BID ADDENDUM NO.1

2181539 Bank on Buffalo, Niagara Falls, NY

There was an error during the printing process that caused the structural & HVAC items to not appear in the Architectural drawings. Some of the drawings being replaced are only to show the missing items for clarification. No actual changes are occurring on these sheets. Any changes to the drawings are clouded & tagged.

A302

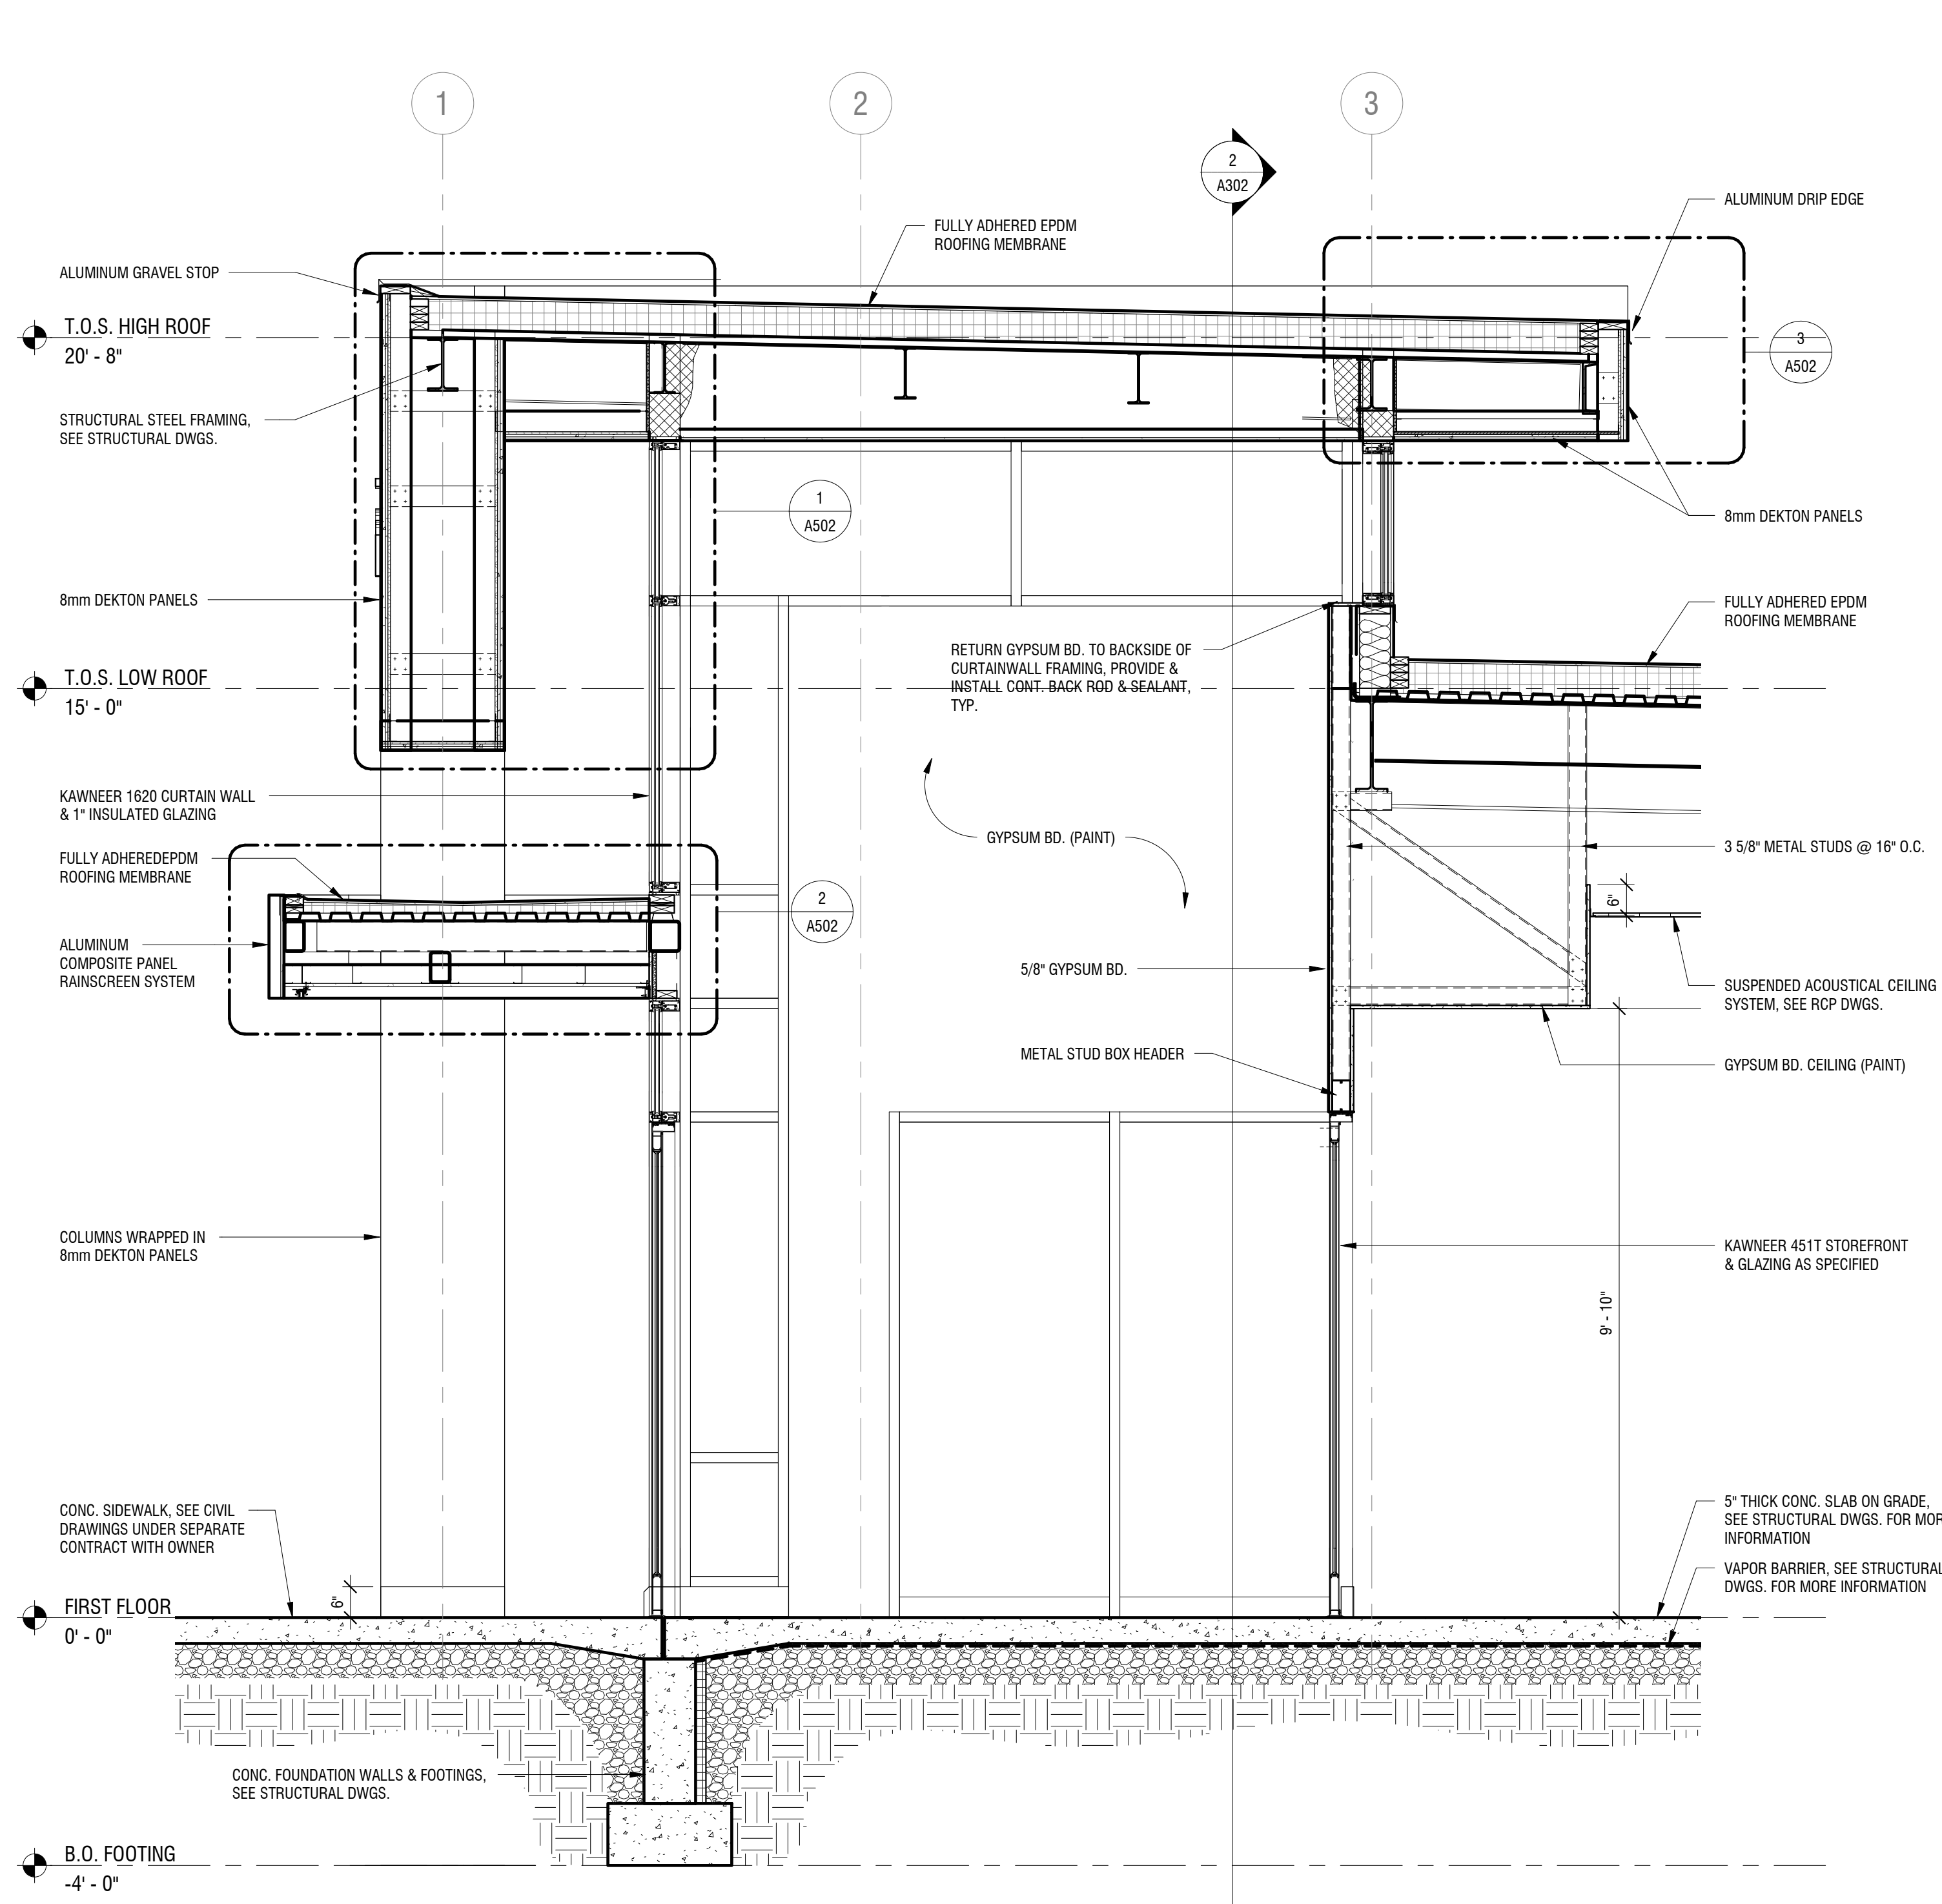
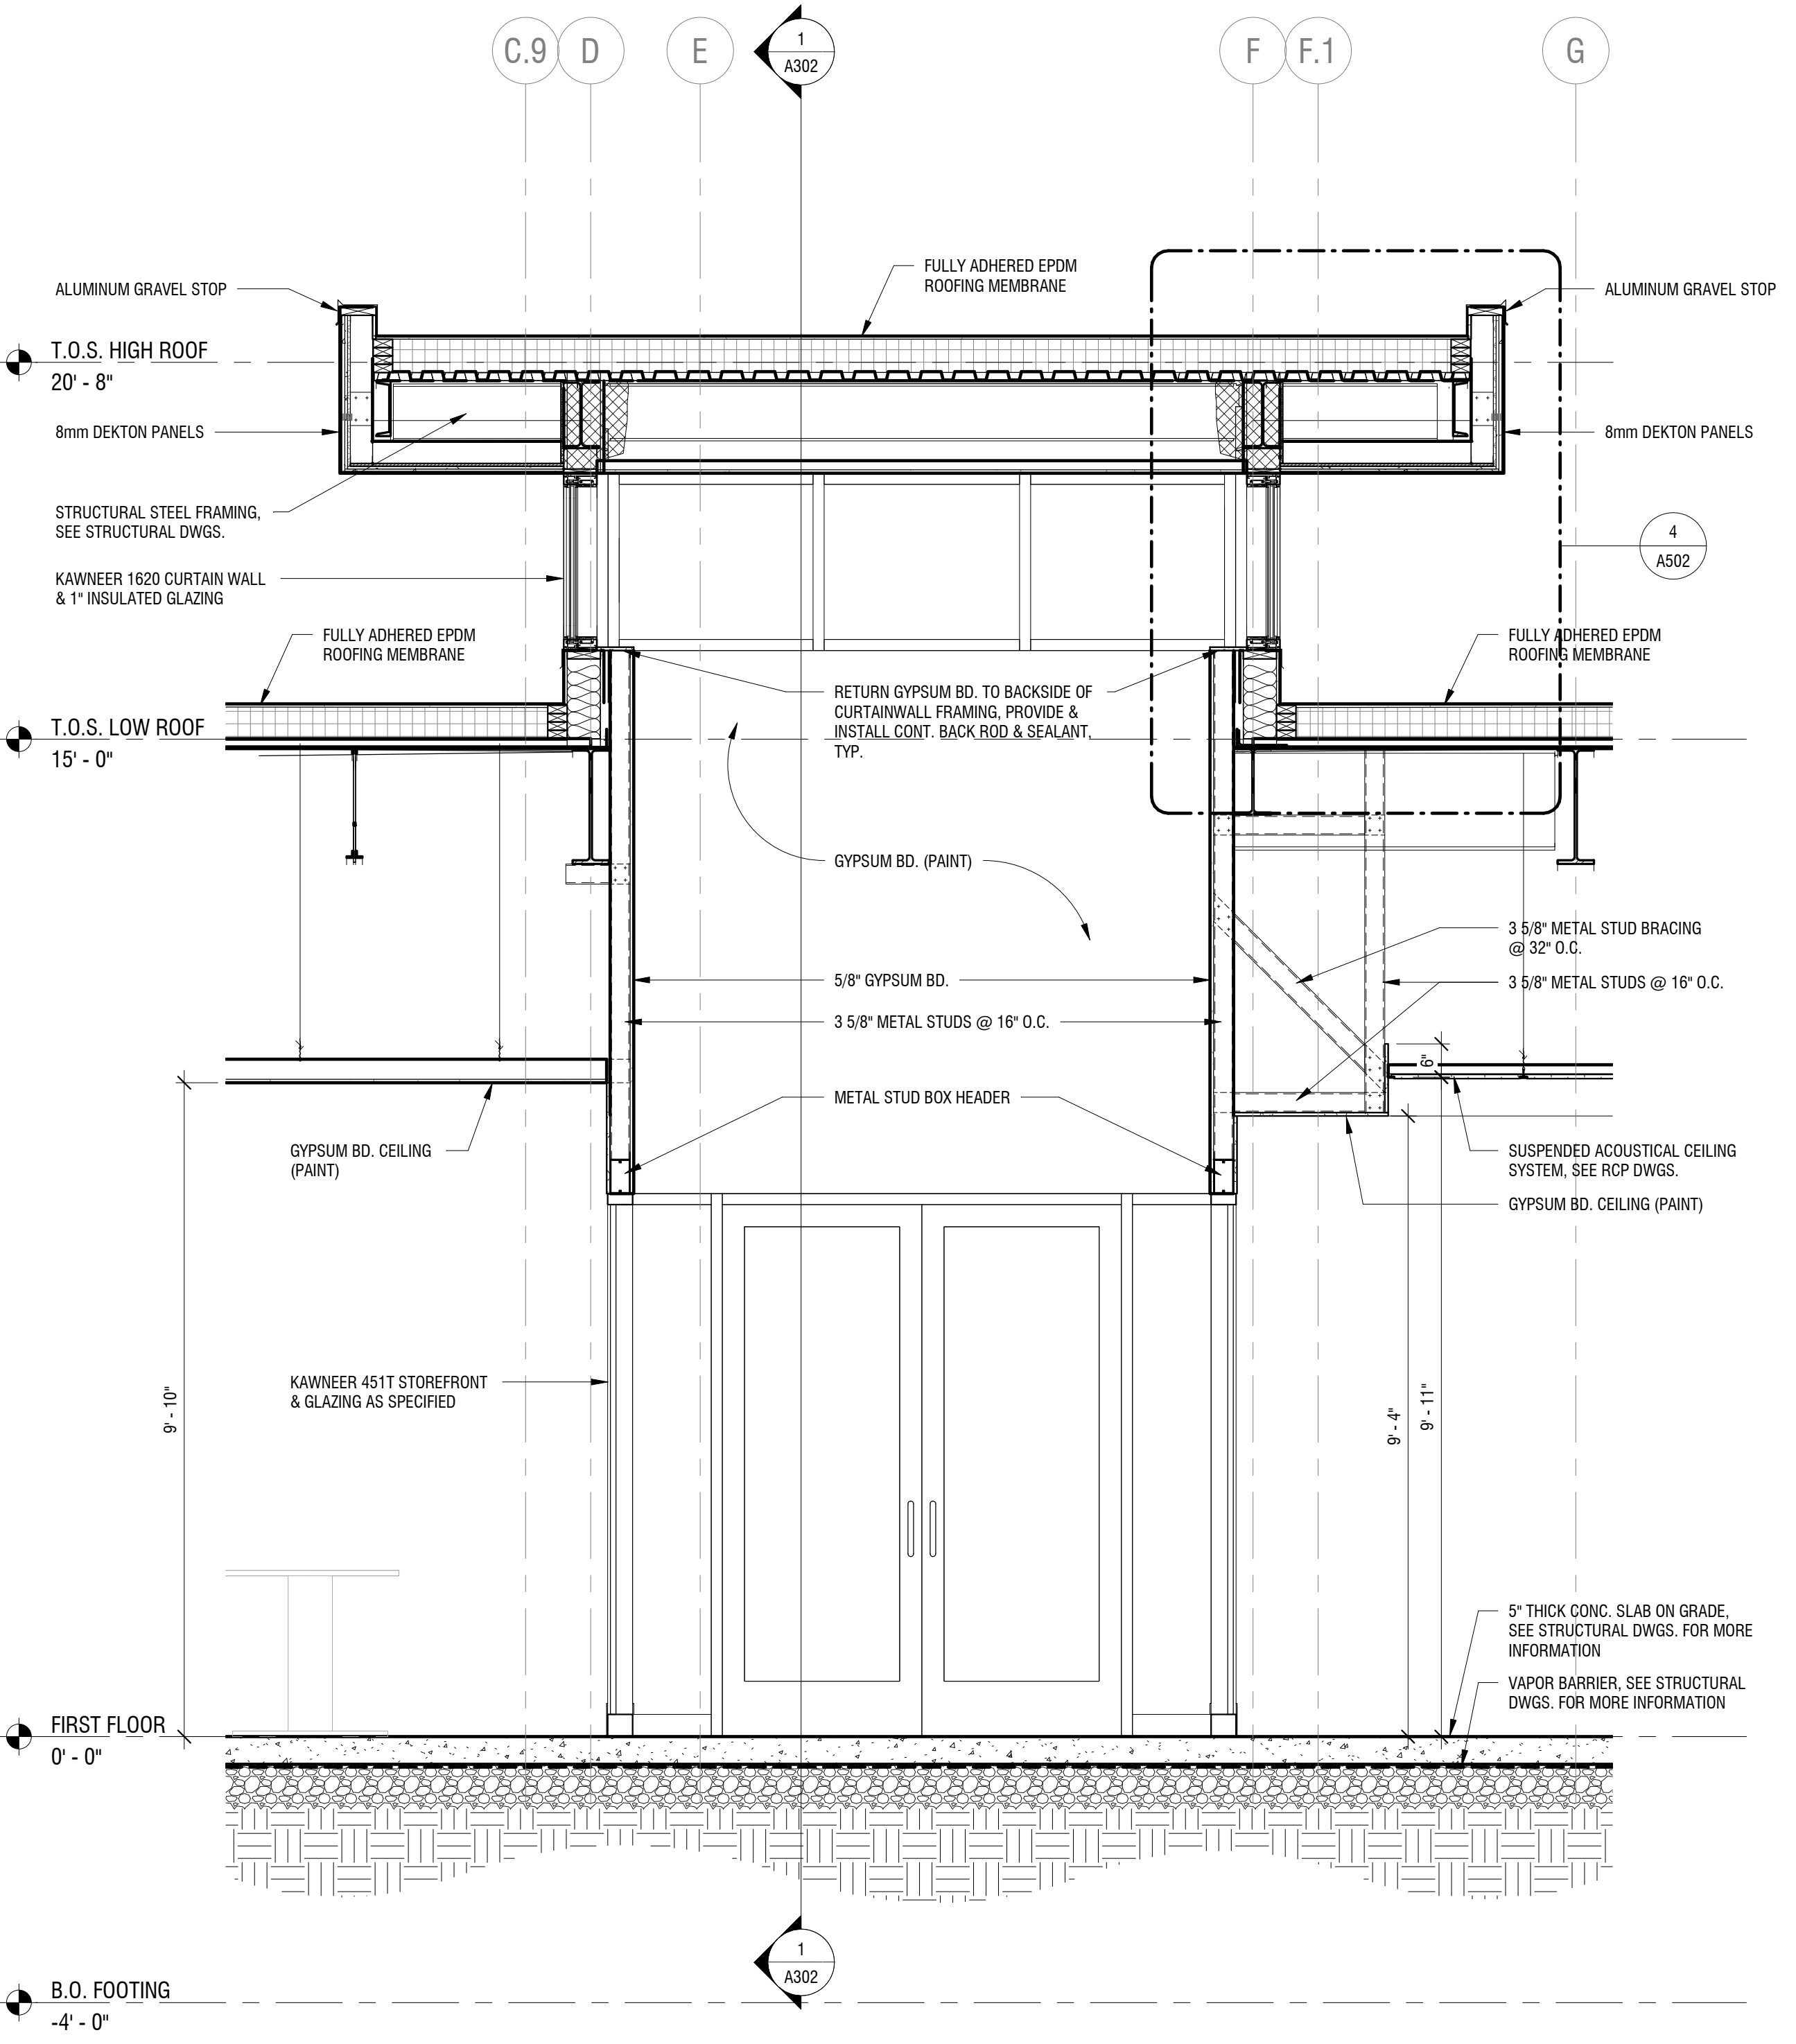
- I. Drawing A302**
 - 1. DELETE Drawing in its entirety
 - 2. ADD replacement Drawing A302
 - 3. HVAC & structural shown on drawings.
